DEVELOPMENT REVIEW COMMITTEE (DRC) COMMENT REPORT

**Project Name: LIPAO FLA 2 LLC / 1416 NE 4th Avenue
Commercial Building**

Case Number: R16009

**Request: Site Plan Level II Review: 1080sf Commercial
Building within 100 feet of Residential Property**

1 SITE PLAN
A-100 1" = 10'-0"

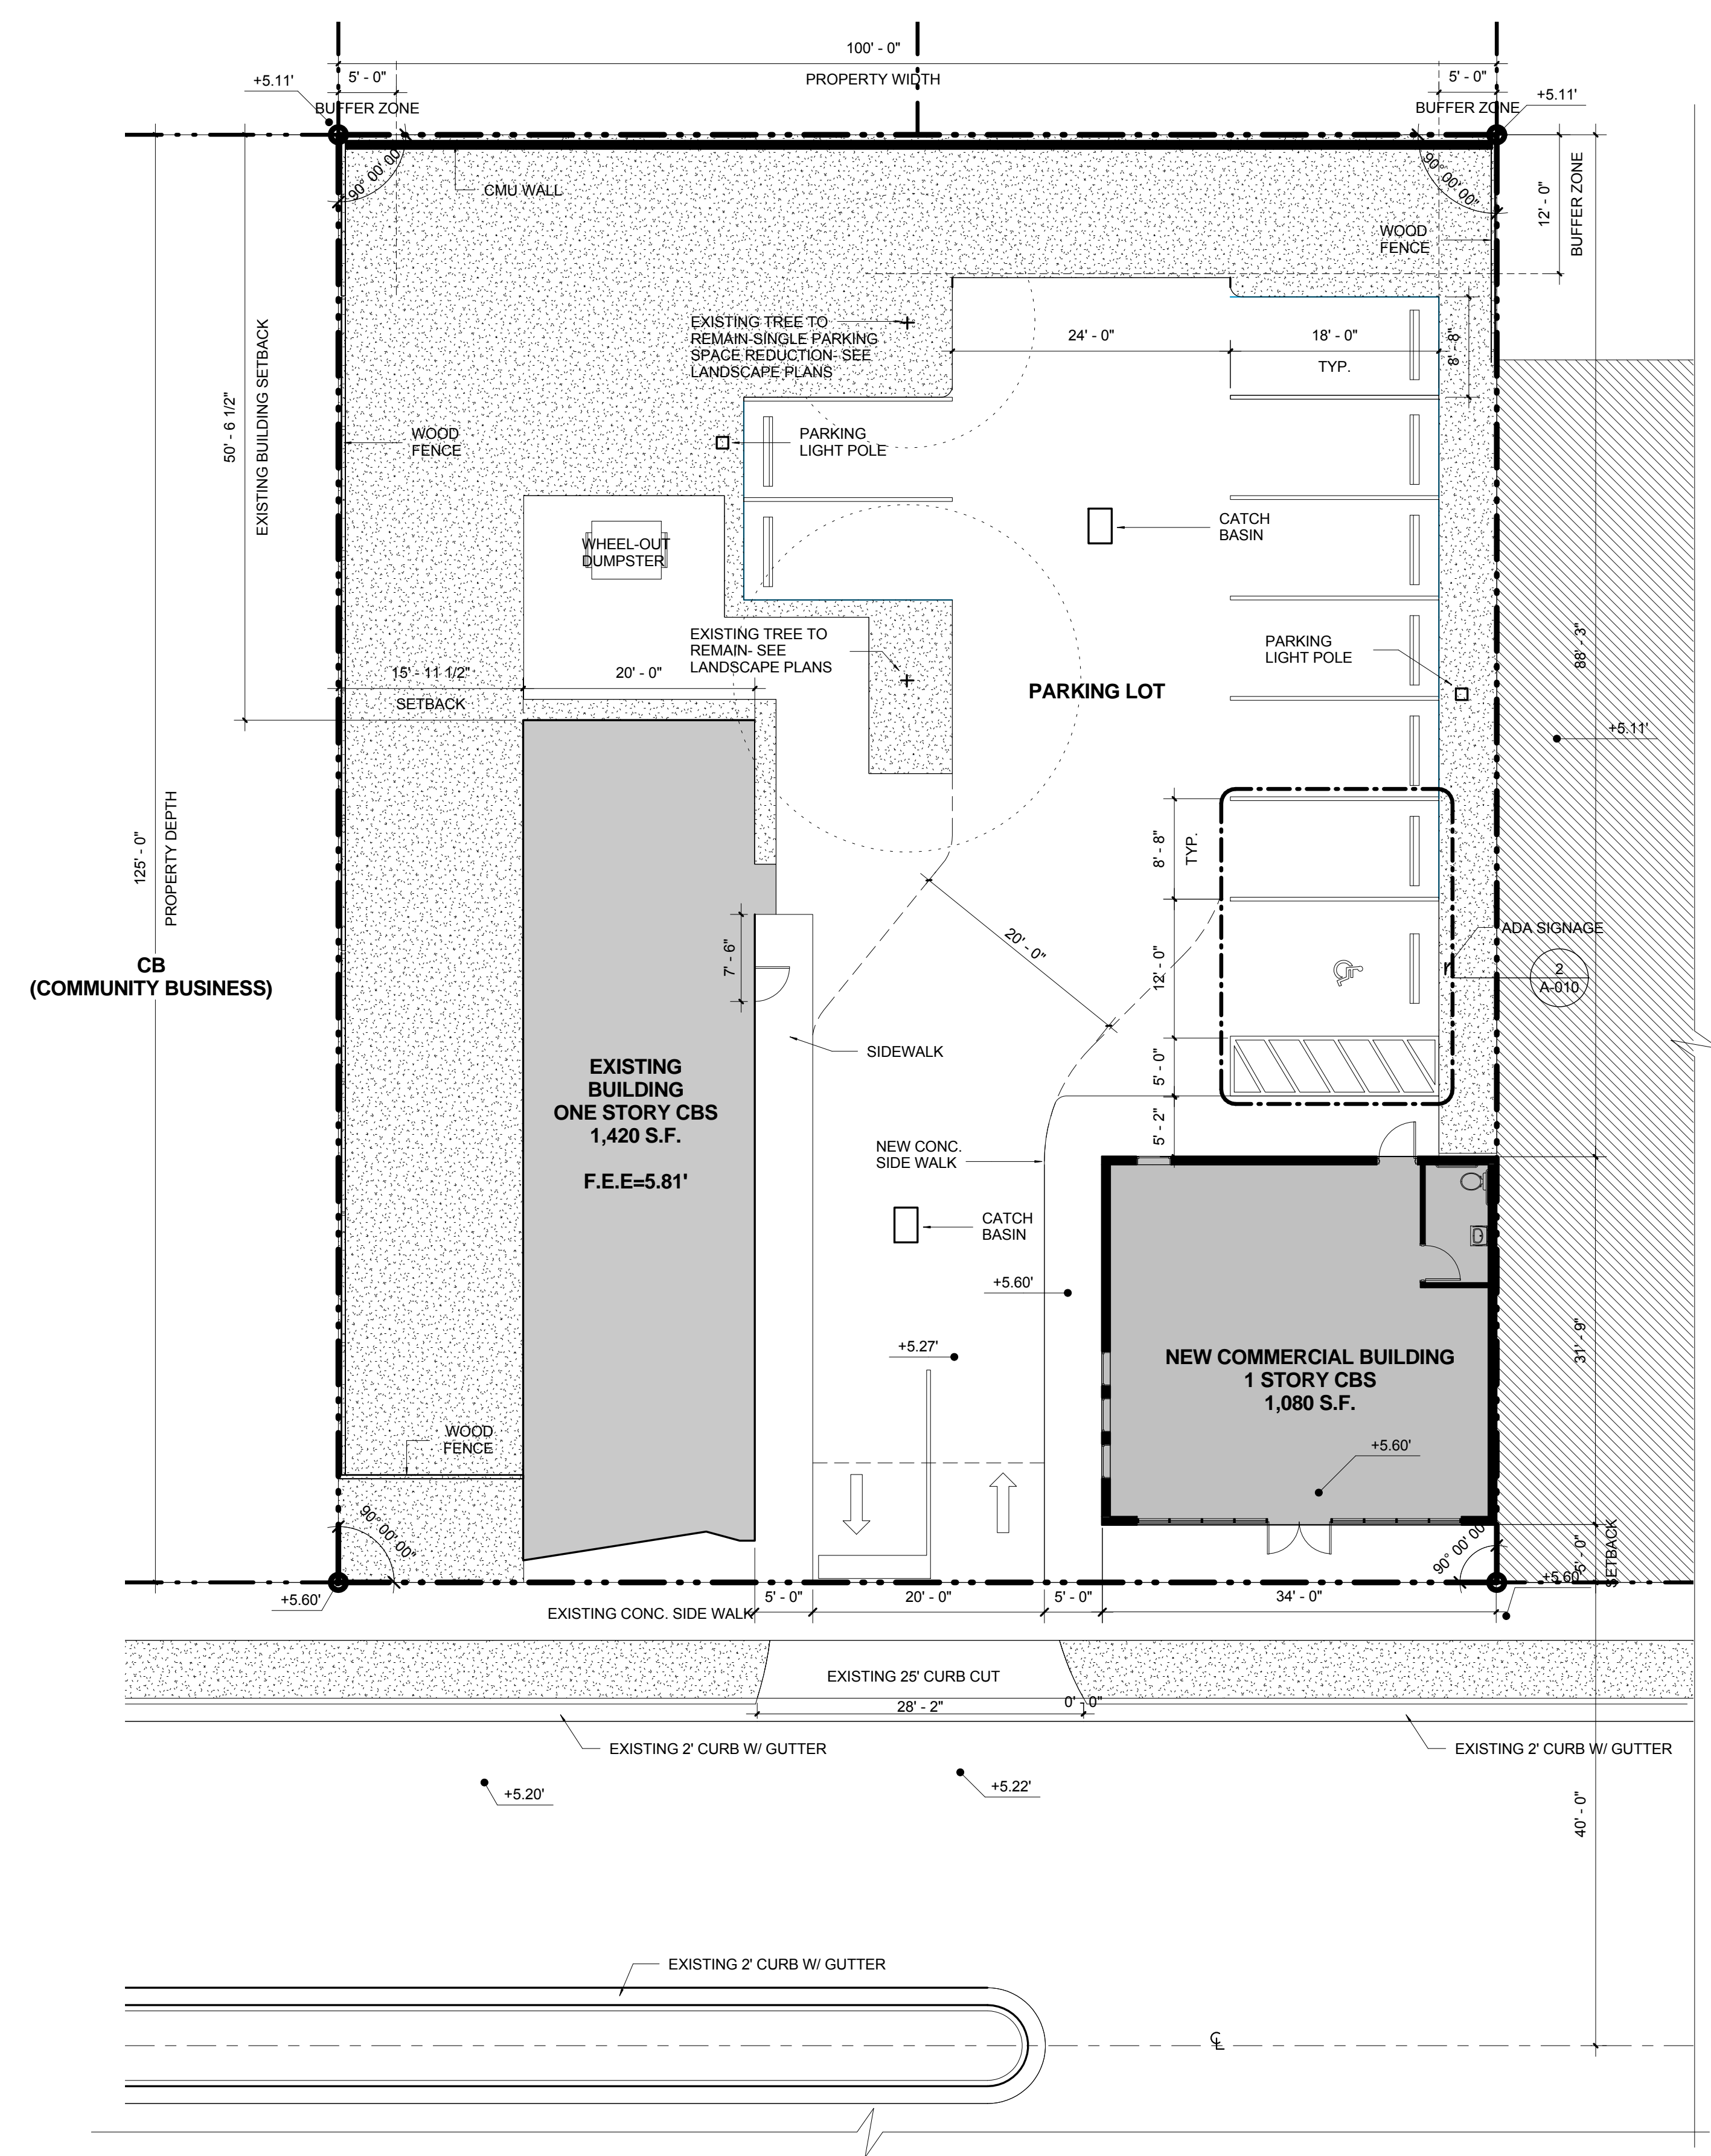
6. Proposed driveway approach to State Road 811 / N.E. 4th Avenue – Show and label FDOT sight triangle (per the most current FDOT Design Standards) on the Site Plan, Landscape Plans, and Civil Plans.

7. Provide pedestrian separation by labeling on-site sidewalks to be 6" higher than adjacent 20' wide driveway (both sides) and parking stalls, such that the sidewalk grading also works with the FFE of existing and proposed buildings; provide ADA Accessibility as appropriate.

8. Consider increasing on-site landscape area by reducing 18' long parking stalls to 16' and replacing concrete wheel stops with concrete curbs (but still allowing for the 2' vehicle overhang areas), and deleting the 2' to 3' additional drive aisle pavement past the last parking stall.

10. Show and label limits of existing canopy located on N.E. 4th Avenue side of existing building structure.
11. Per ULDR Section 47-2.2.Q, show and label sight triangles as appropriate for safe and adequate access of drivers and pedestrians, on the Site Plan, Landscape Plans, and Civil Plans: intersections of driveways with streets (measured from pavement edges), alleys with alleys (measured from property lines extended), alleys with streets (measured from property lines extended), and streets with streets (measured from property lines extended). Per ULDR Section 47-19.1.E, no accessory use or structure shall be permitted within a sight triangle except as provided in [ULDR Section 47-35](#).

6. Solid Waste Collection shall be on private property. Container shall not be placed, stored or block the public street to perform service (large multifamily and commercial parcels). Please show on your site plan where the container will be placed for service by the collection truck.

7. Provide on the site plan a garbage truck turning radii for City review. Indicate how truck will circulate within property.
8. Commercial – Strip stores shall share bulk container to avoid each tenant having a dumpster.

12. Provide on the site plan bollard placement.
13. Submit a Solid Waste Management Plan on your letterhead containing name of project, address, DRC case number, number of units if applicable, and indicate whether it is Pre or Final DRC.
